Customer : CU-DAR001 Dart Helicopters Services Drawing Name : SKID TUBE ASSEMBLY
 Job Number : 32966
 Estimate Number : 12520
 P.O. Number : N/A Part Number : D205634045
 This Issue : 6/19/2007 S.O. No. : N/A Drawing Number : D2580 REV C/DE09183B
 Prsht Rev. : NC Project Number : N/A
 First Issue : N/A Type : LANDING GEAR Drawing Revision : C/B
 Previous Run : 32965 Material : N/A
 Due Date : 7/11/2007 Qty: 1 Um: Each
 Written By :
 Checked & Approved By : 07.06.20
 Comment : Est Rev: C Revised Steps 06-09-06 JLM

DESIGN <i>[Signature]</i>	DRAWN BY <i>[Signature]</i>	DART AEROSPACE LTD HAWKESBURY, ONTARIO, CANADA	
CHECKED <i>[Signature]</i>	APPROVED <i>[Signature]</i>	DRAWING NO. D2580	REV. C SHEET 1 OF 2
DATE 98.08.26		TITLE 205 SKIDTUBE ASSEMBLY	SCALE NTS
A	96.09.16	NEW ISSUE	
B	96.12.02	AS MANUFACTURED	
C	98.08.26	REDRAWN, INCLUDED DEO 9094/9097

DESIGN RF	DRAWN BY RF	DART AEROSPACE LTD HAWKESBURY, ONTARIO, CANADA	
CHECKED #	APPROVED #	DRAWING NO. DEO 9183	REV. B SHEET 1 OF 1
DATE 00.05.15		TITLE ADD SKIDTUBE P/N D2580-045	SCALE NTS
A	00.03.29	NEW ISSUE	
B	00.05.15	39.580 WAS 39.620

AMEND DRAWING D2580 REV. C TO ADD D2580-045 ASSEMBLY

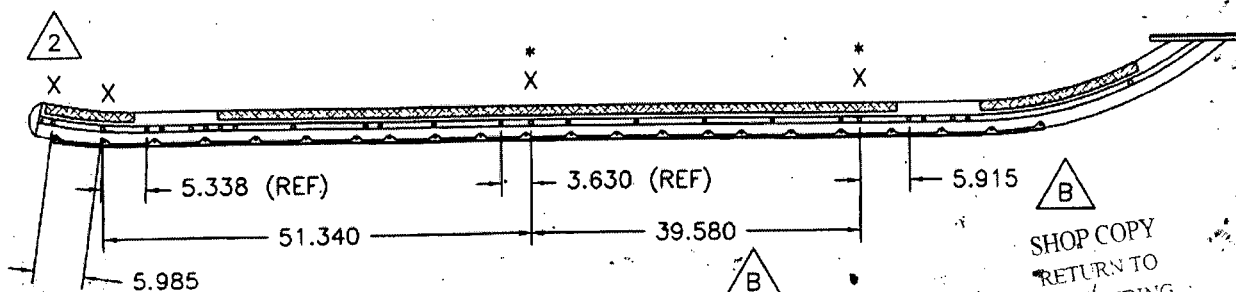
D2580-045 IS IDENTICAL TO D2580-041, EXCEPT FOR THE FOLLOWING CHANGES:

- 1) INSTALL CROSS BOLT SPACERS AT LOCATIONS MARKED 'X' ACCORDING TO THE FOLLOWING PROCEDURE.
 - a) DRILL $\varnothing 0.508$ HOLES AT LOCATIONS SHOWN BELOW MARKED 'X'. CHAMFER HOLES $0.030 \times 45^\circ$. NOTE THAT HOLES WILL ALSO HAVE TO BE TRANSFERRED TO THE D2596 WEB AT THE * LOCATIONS. IT IS ACCEPTABLE TO PRE-DRILL THE D2596 WEB IN THESE LOCATIONS BEFORE INSTALLING THE WEB IN THE SKIDTUBE. OPEN HOLES TO $\varnothing 0.63$ AND TOUCH UP WITH ALODINE PER QSI 005 4.1.

- b) INSERT D2579 CROSS BOLT SPACERS INTO THE HOLES.
 - c) WELD INTO PLACE PER DART QSI 004 AND GRIND FLUSH.
 - d) REMOVE SPILL OVER, LEAVING HOLE DIMENSION $\varnothing 0.380$ - $\varnothing 0.390$.

- 2) IT IS ACCEPTABLE TO GRIND A RELIEF IN THE D2855 AFT CAP TO PREVENT INTERFERENCE WITH THE SPACER AT THIS LOCATION.
- 3) POWDER COAT ENTIRE ASSEMBLY GREEN (REF. 4.3.5.8) PER DART QSI 005 4.3 INSTEAD OF WHITE (REF. 4.3.5.1).

D205-634-015 (D205-634-045)

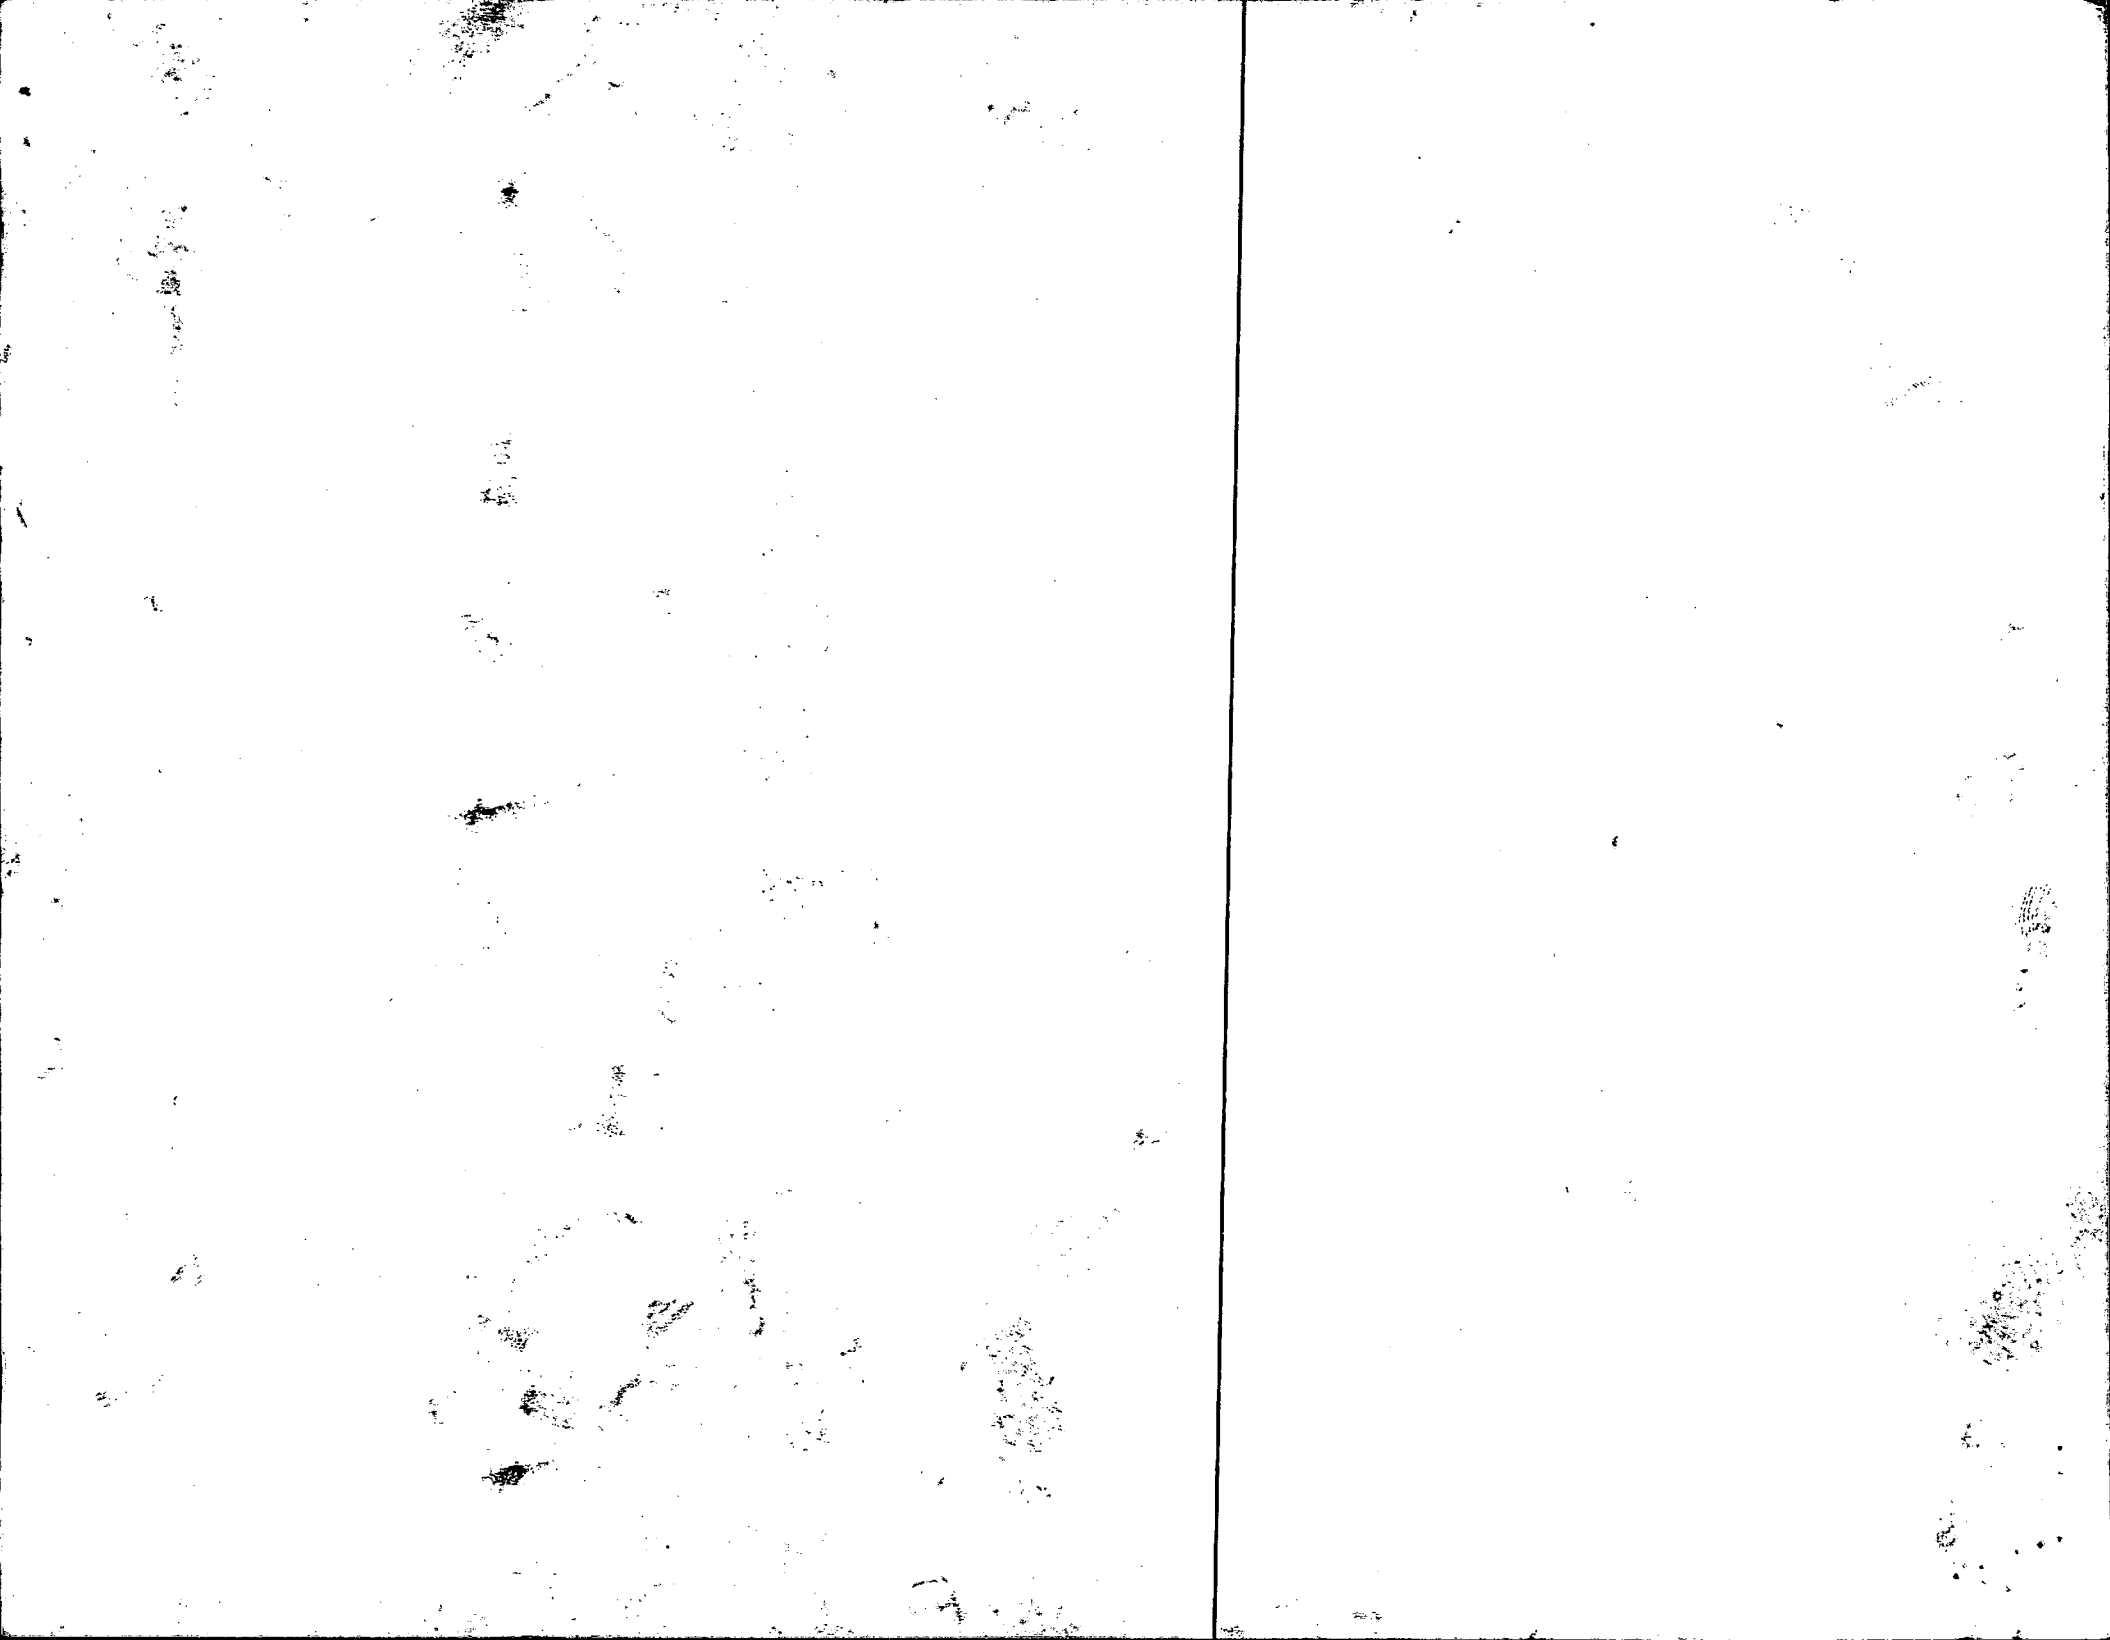
ADD D205-634-015 INSTALLATION. PARTS LIST IS IDENTICAL
TO PARTS LIST FOR D205-634-011 EXCEPT THAT:
D205-634-045 REPLACES D205-634-041
D2580-045 REPLACES D2580-041

THE DIFFERENCE BETWEEN D205-634-011 (D205-634-041)
AND D205-634-015 (D205-634-045) IS THAT EXTRA
SPACERS HAVE BEEN ADDED AT LOCATIONS MARKED 'X' AND
ASSEMBLY IS PAINTED GREEN.
